**ADDENDUM NO. 1**

**MONTAGUE**  
**Federal Aid Project No. STP(BR-OFF)-003S(734)X**  
**Bridge Replacement, M-28-026, South Street over Sawmill River**

RESPONSES TO CONTRACTORS' QUESTIONS

ADDENDUM NO. 1, APRIL 18, 2024

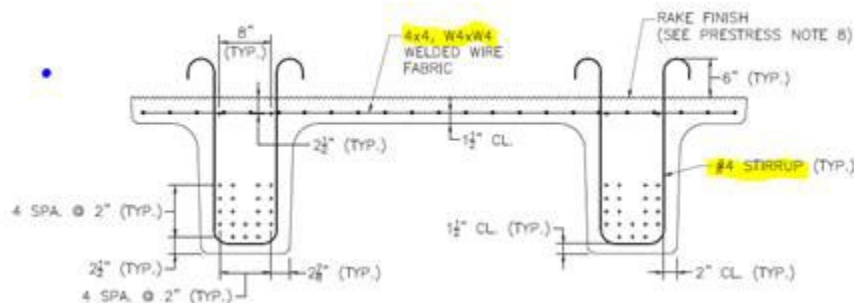
**Question #2:** Can we change the 4x4 W4xW4 WWF in the NEXT Beams to rebar with an equivalent steel area? The #4 stirrups that come up through do not fit through the 4x4 spacing.

Below is the detail for reference.

**Response #2:** Mild steel reinforcing bars may be used in place of welded wire reinforcement provided an equivalent area of steel is maintained and the bar spacing does not exceed 12”.
